1983–1991 Chevrolet Suburban, CK Pickup Series, and Blazer Replacement Condenser: 3642C

TECH TIP

3642C · Parallel Flow Style Replacement Condenser

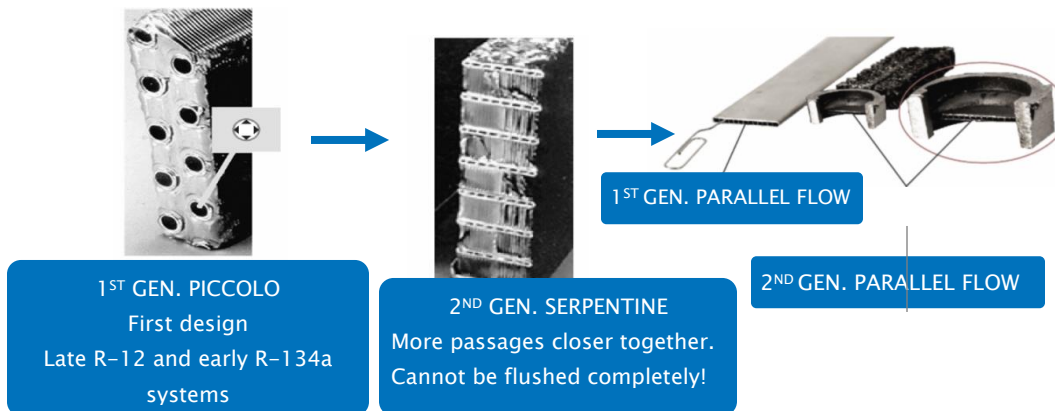
Due to model updates, the replacement condenser and original condenser design may vary for the applications listed above. The original, 1st generation design, is a piccolo style condenser. Most replacement options on the market today will feature the 2nd generation design, a parallel flow style condenser. In addition to style changes, the 2nd generation design is shorter in length compared to the original serpentine condenser design and may require mounts to be adjusted.
